Application for Development Before Zoning Board of Adjustment and Planning Board
(§ 245-12B)

We have received a copy of the above-referenced application for preliminary and final site plan approval. The subject of the application is the construction of a Dollar General retail store and associated infrastructure improvements. The 2.34-acre site has frontage on Ridgeway Road (County Route 571), Washington Avenue and Richmond Avenue, and is within the B-1 Business Zone.

Robert A. Mullin, P.E., P.P., C.M.E., C.P.W.M.
Planning Board Engineer

UNDERGROUND OUTLET STRUCTURE (OS-1) DETAIL

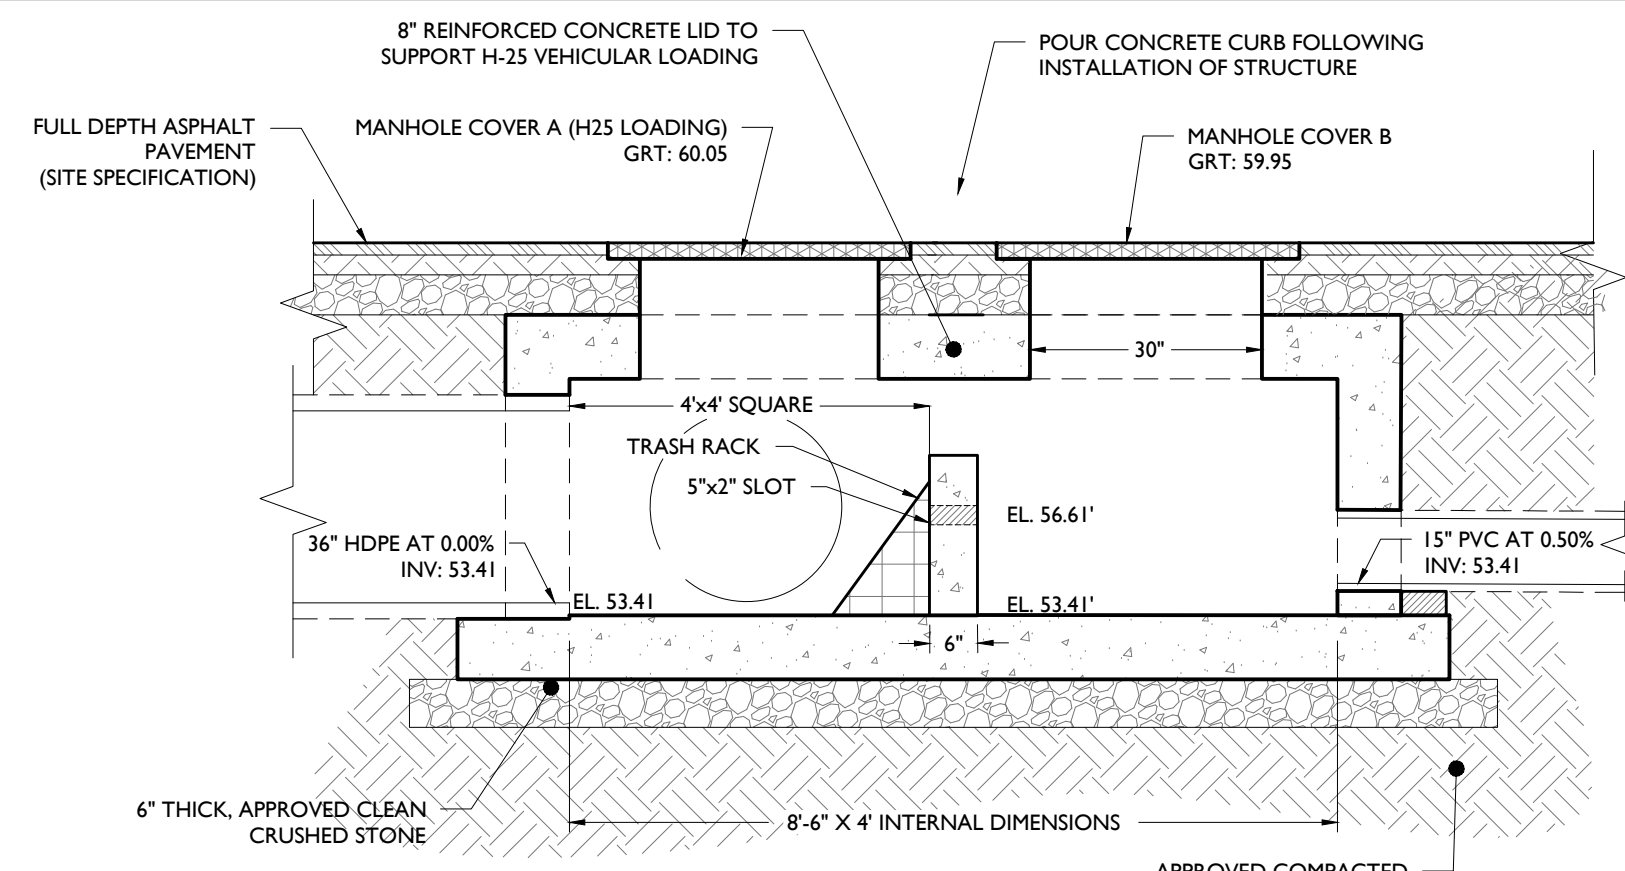
10. The time of concentration flow paths shall be indicated on the existing drainage area map.
11. The underground outlet structure (OS-1) detail shows a 36" HDPE. The plans depict a 48" HDPE. Correct the discrepancy.

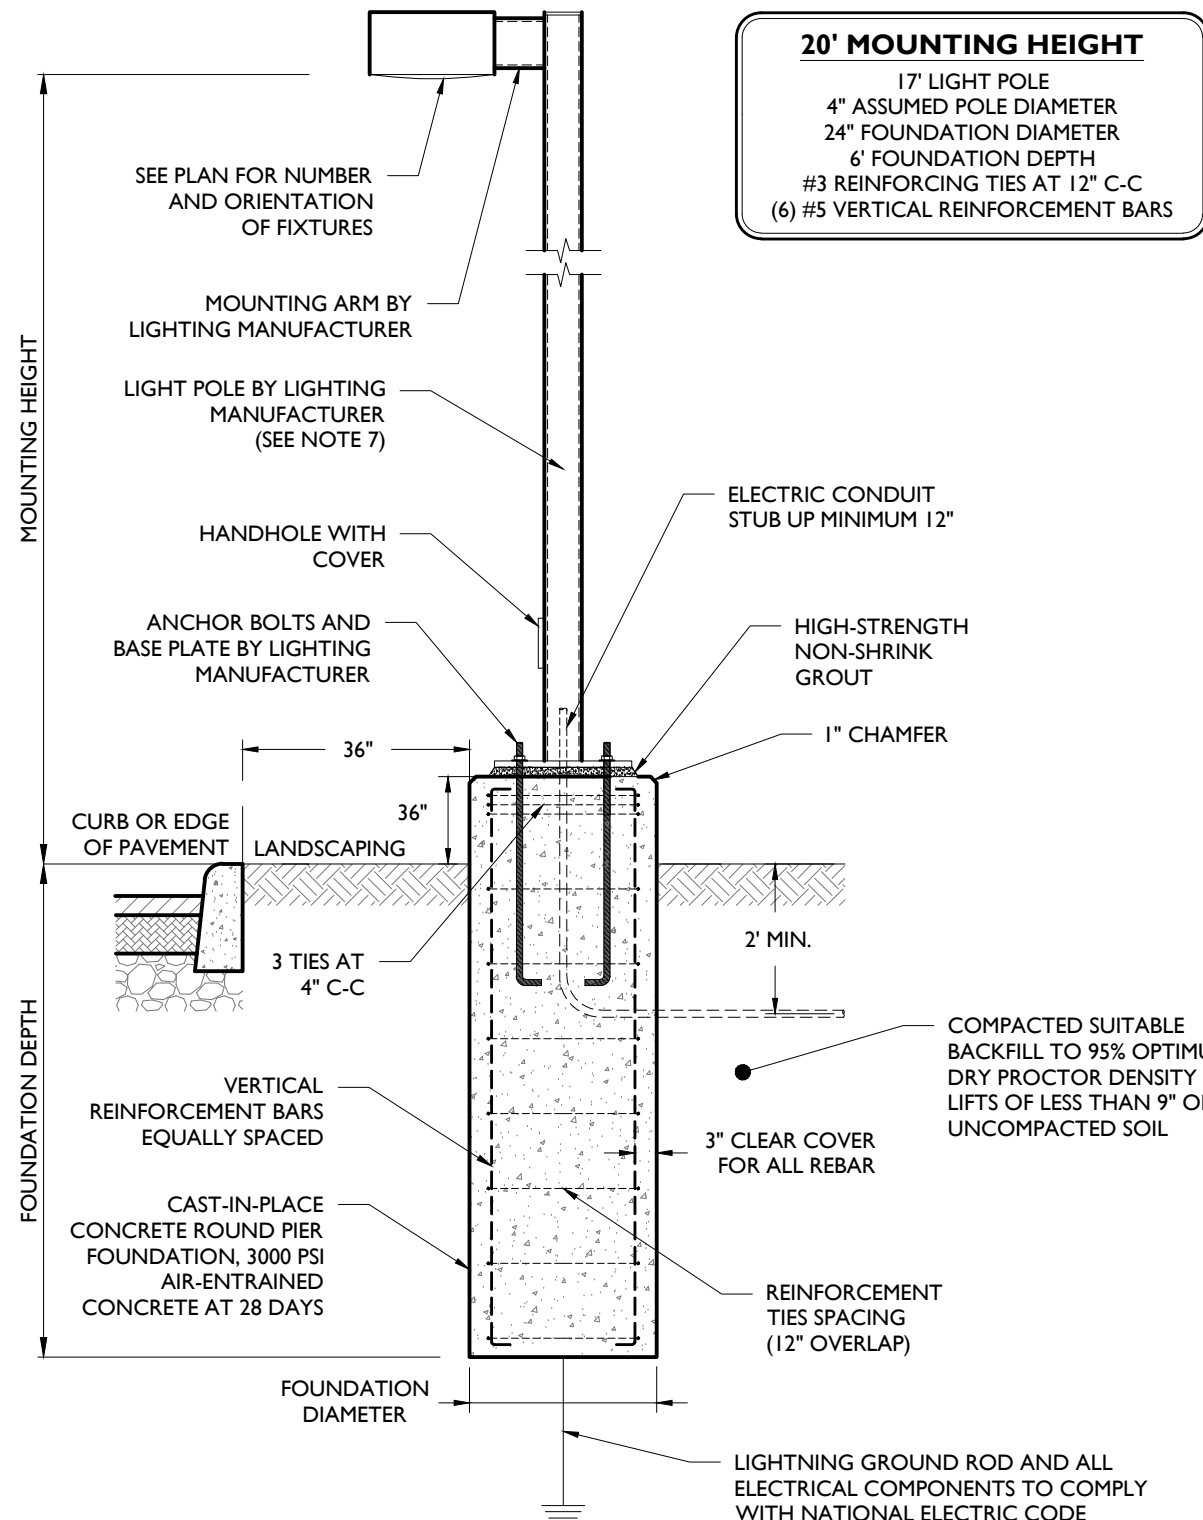
- 2.7. The Applicant is proposing 3 bioretention basins as part of the overall stormwater management system. According to the Chapter 9.1 of the New Jersey Stormwater Best Management Practices, a bioretention system consists of "a soil bed planted with native vegetation located above an underdrained sand layer". The plans include details for each of the 3 basins, and the details refer to the landscaping plans for basin area plantings. The landscaping plan, however, does not appear to depict any plantings within the 3 basins. Additional information is required.
